Addendum No. 4 **Issued: November 17, 2026**

Project Name:	Pottsgrove High School Facilities & Athletic Improvements ICS Project No. S25009
Project Owner:	Pottsgrove School District 1301 Kauffman Road Pottstown, PA 19464
Construction Manager:	ICS – Scott Kennedy 1400 N. Providence Road Building 2, Suite 4025 Media, PA 19063

MECHANICAL PLAN - HOME SIDE
CONCESSIONS AND RESTROOM BUILDING

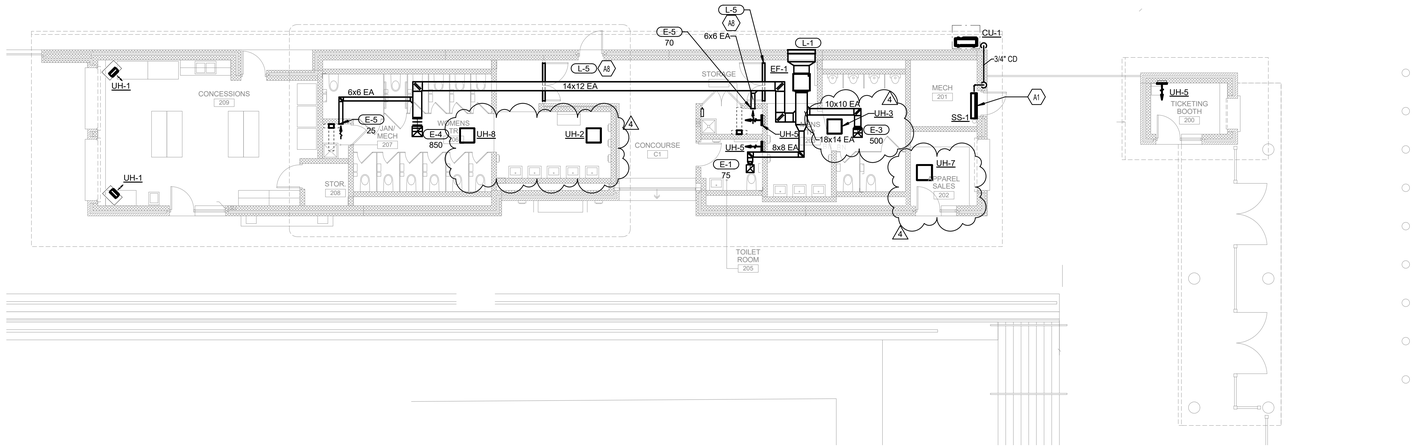
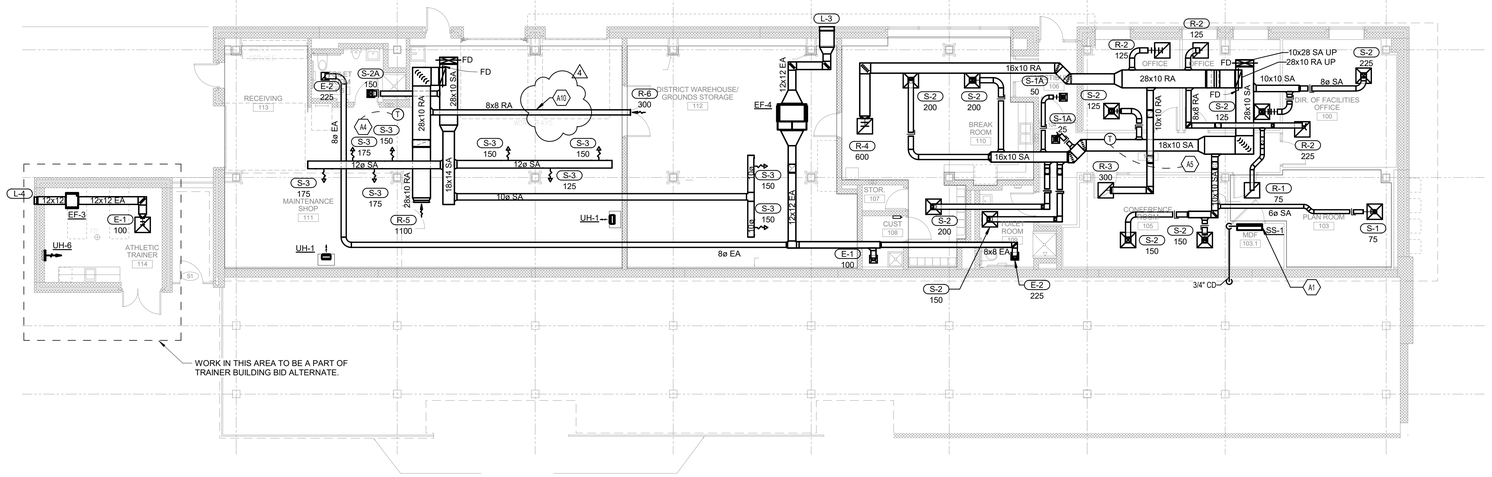
5.37 Drawing Sheet M-201 “MECHANICAL PLAN - HOME SIDE PAVILLION” (Reference attached Reissued Drawing):
- Changed unit heaters UH-2, UH-3, and UH-6 in rooms 206, 203, and 202 to be ceiling heaters. Refer to drawings and mechanical schedules.
- Added tagged note A10 to RA ductwork routed above coiling doors in grounds work bay room.

MECHANICAL PLAN - VISITORS SIDE
CONCESSIONS AND RESTROOM BUILDING

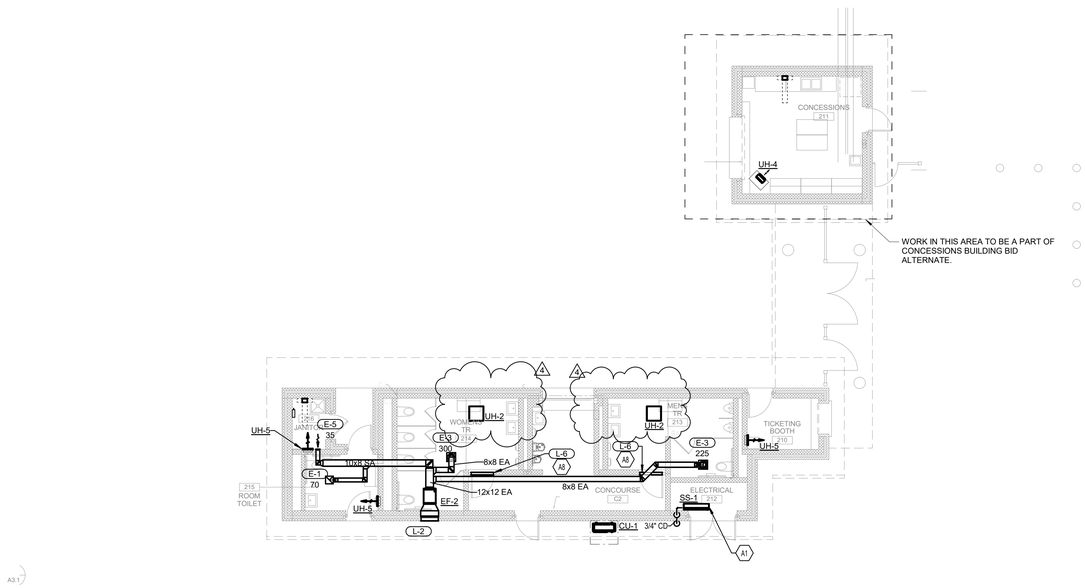
5.38 Drawing Sheet M-202 “MECHANICAL PLAN – VISITORS SIDE PAVILLION” (Reference attached Reissued Drawing):
- Changed unit heaters UH-4 in rooms 214 and 213 to be ceiling heaters. Refer to drawings and mechanical schedules.

UNDERSLAB PLUMBING PLAN - HOME SIDE UNDER BLEACHERS

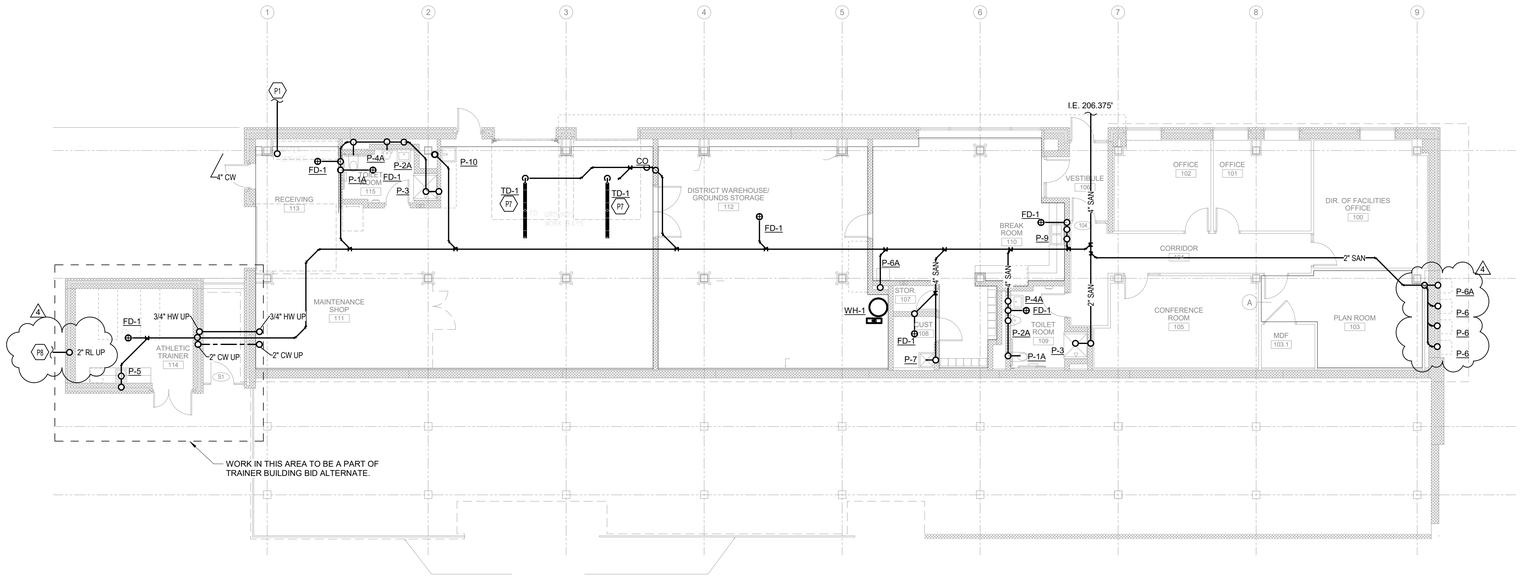
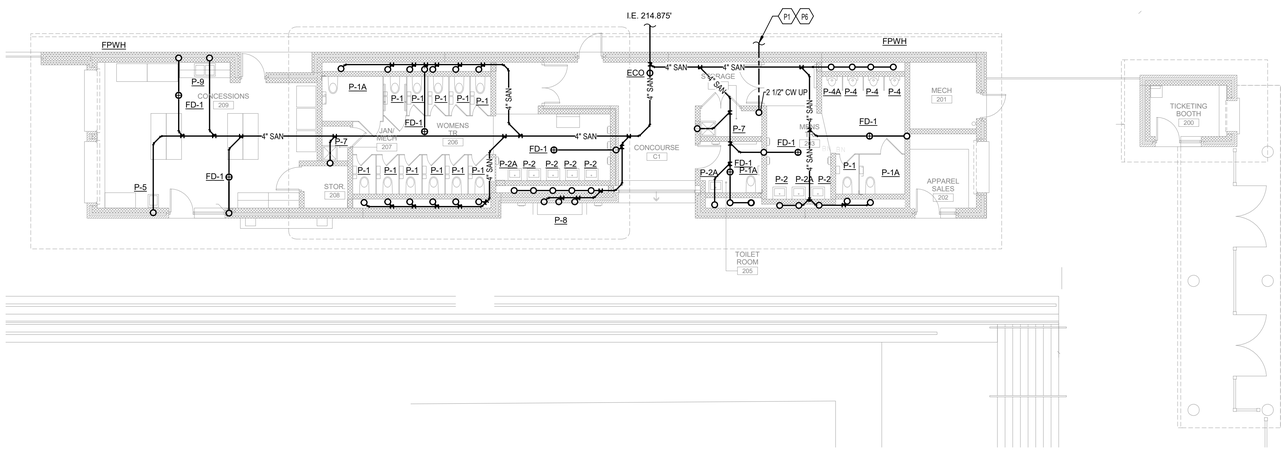
5.41 Drawing Sheet P-201 “UNDERSLAB PLUBMING PLAN – HOME SIDE PAVILLION” (Reference attached Reissued Drawing):
- Adjusted sanitary piping serving drinking fountains on exterior wall to align with architectural background.
- Added roof leader piping to service roof drain in athletic trainer’s room.

UNDERSLAB PLUMBING PLAN - VISITORS SIDE CONCESSIONS AND BLEACHERS

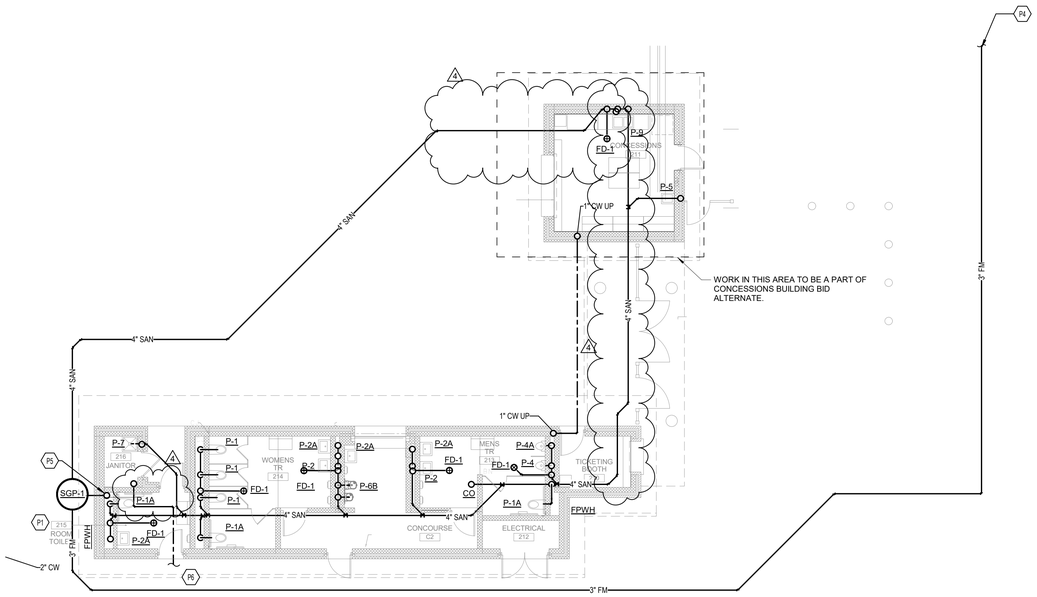
5.42 Drawing Sheet P-202 “UNDERSLAB PLUMBING PLAN – VISITORS SIDE PAVILLION” (Reference attached Reissued Drawing):
- Adjusted visitor’s side underslab pipe routing.

PLUMBING PLAN - HOME SIDE UNDER BLEACHERS

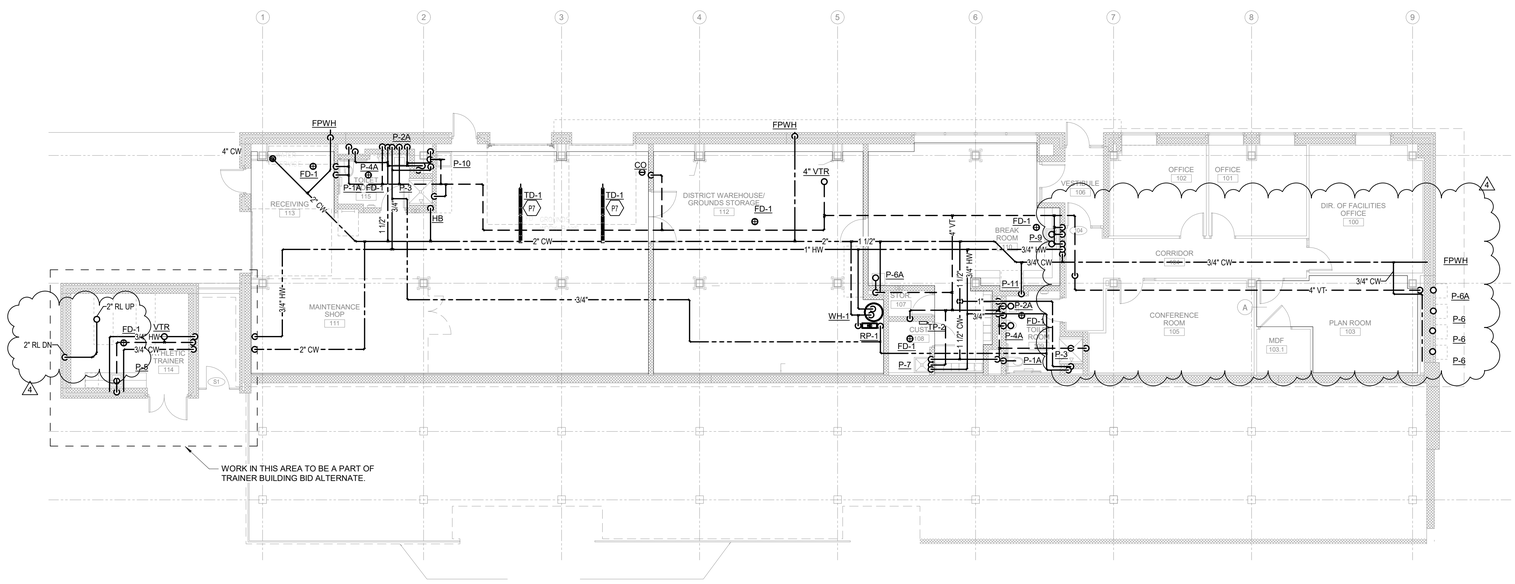
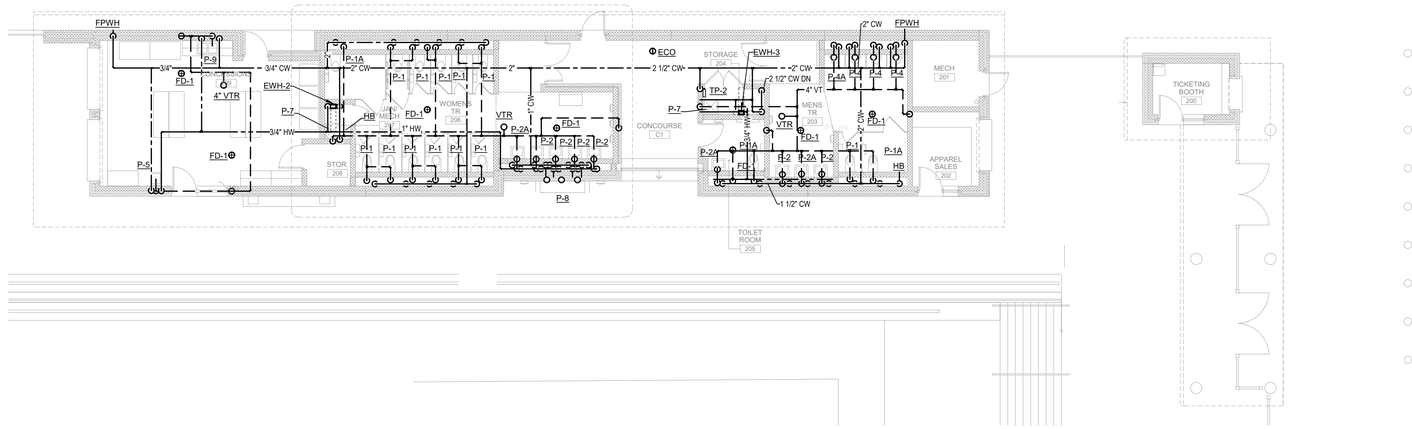
5.43 Drawing Sheet P-301 “PLUMBING PLAN - HOME SIDE PAVILLION” (Reference attached Reissued Drawing):

- Added vent piping to serve drinking fountains on exterior wall.
- Adjusted sanitary piping serving drinking fountains on exterior wall to align with architectural background.
- Added roof leader piping to service roof drain in athletic trainer’s room.
